CITY OF ST. PETERSBURG, FLORIDA
PLANNING AND DEVELOPMENT SERVICES DEPARTMENT
URBAN PLANNING AND HISTORIC PRESERVATION DIVISION

STAFF REPORT

Community Planning and Preservation Commission Certificate of Appropriateness Request

Case No.:	21-90200083
Address:	501 5 th Avenue Northeast
Legal Description:	VINOY REPLAT BLK 1, PT OF LOT 1 (HISTORIC LANDMARK HOTEL) (VINOY HOTEL PH 1&2 LEASE TO FEB 22, 2090) DESC BEG NE COR OF LOT 1 TH S12DW 69FT TH CUR LT RAD 5767.87 FT ARC 136.52FT CB S09DW 136.51FT TH W 620.9FT TH S 397.58FT TH W 916.7FT TH N 112.06FT TH N32DE 334.99FT TH E 169FT TH N30DE 155.44FT TH E 78.45 FT TH N 67.52FT TH E ALG 7TH AVE NE 1072.5FT TO POB CONT 10.72 AC(C)
Parcel ID No.:	17-31-17-94240-001-0010
Date of Construction:	1925

The Vinoy | 2 - Decks & Patios | 3- Doors and Entries | 6 - Windows

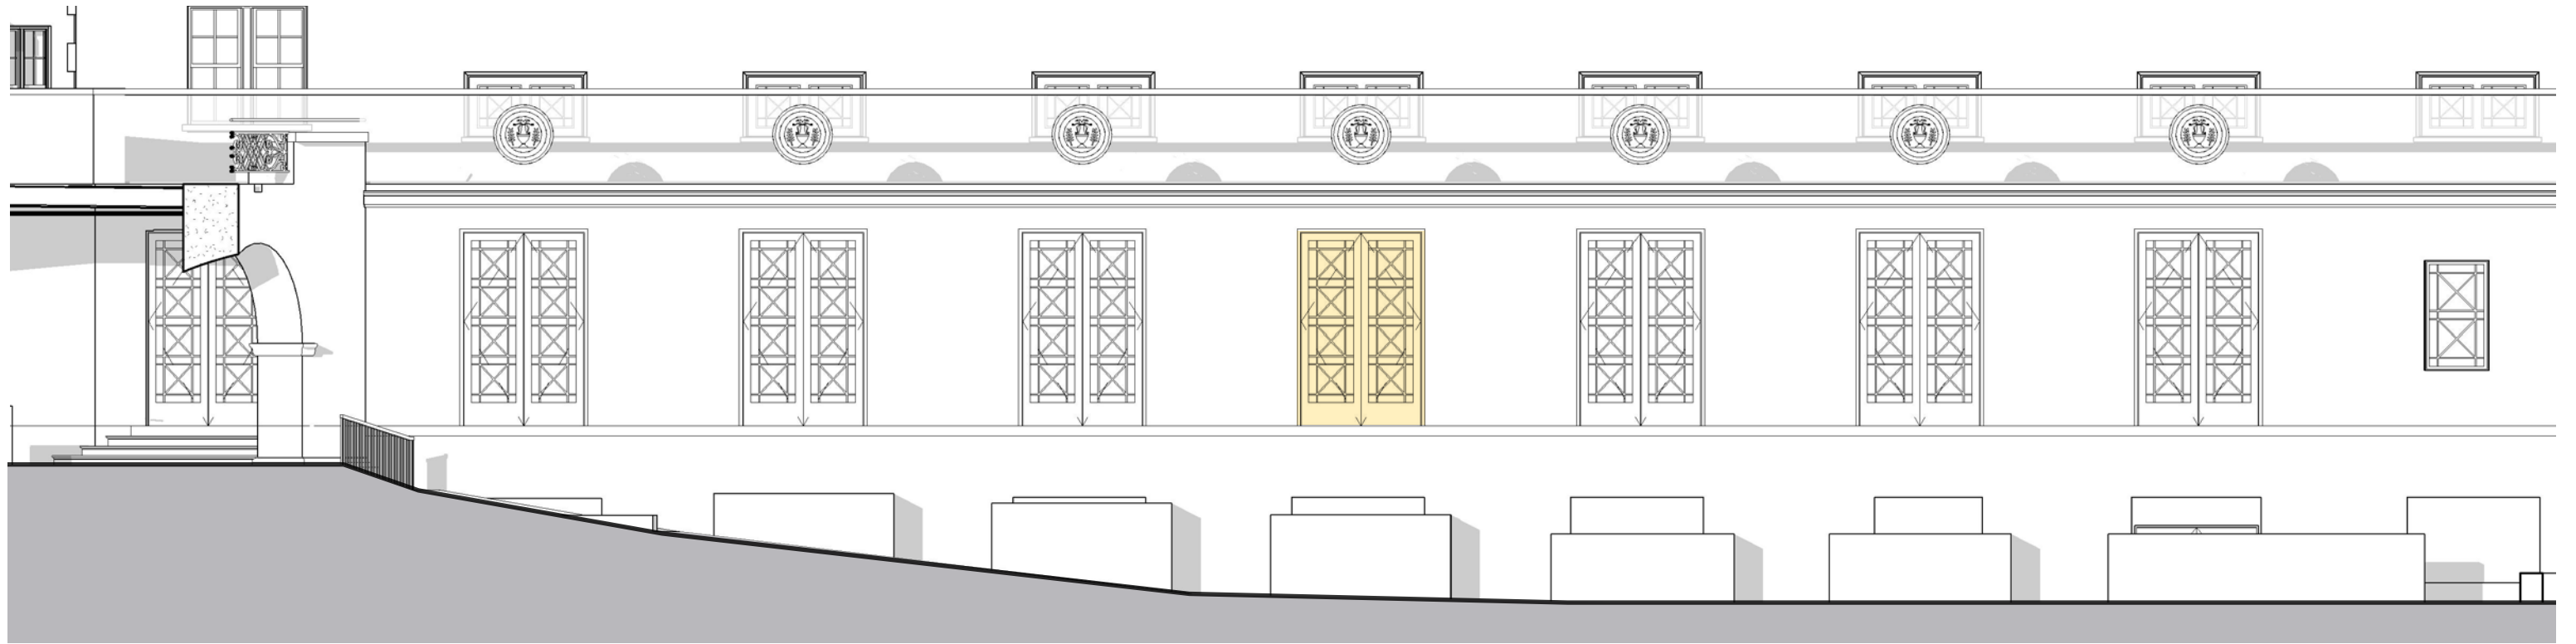
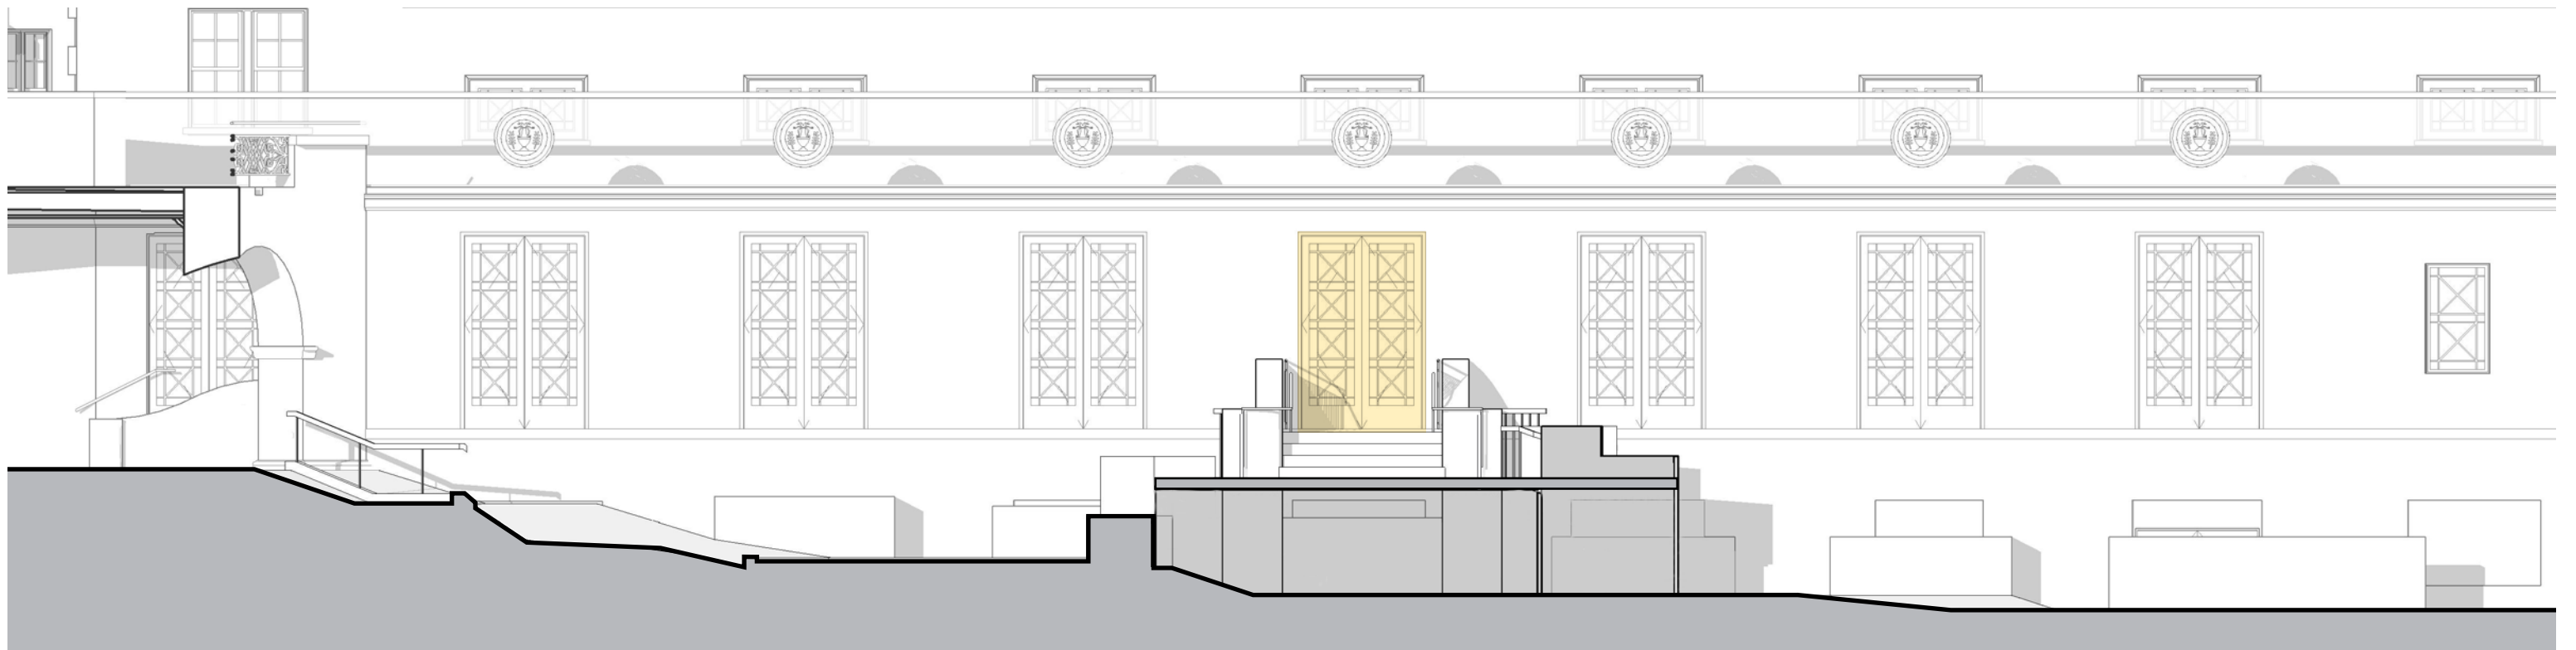
The application also includes installing a new entrance stair to Marchand's Restaurant in the east wing. Historic photographs depict that the east wing has always contained seven paired doors that are elevated above the ground without any access from the front courtyard. The applicant wants to build an entryway to the restaurant from the proposed patio area. While this does alter the original intent of the wing, the entryway could be removed at a later time with little impact on the historic building.

1. Shop drawings of the proposed replacement Marchand's doors be submitted for staff review to confirm the new doors will match the historic doors in design, materials, configuration, and profile. Changes to the swing operation of the doors, such as door hinges, will not be visible from the exterior.
2. Doors will be installed to be setback within the wall plane and feature a reveal of at least two inches, to match existing door reveal.
3. Wooden exterior casing and trim will be reinstalled in kind.
4. A historic preservation final inspection will be required.
5. All other necessary permits shall be obtained. Any additional work shall be presented to staff for determination of the necessity of additional COA approval.
6. This approval will be valid for 24 months from the date of this hearing, with an expiration date of September 14, 2023.
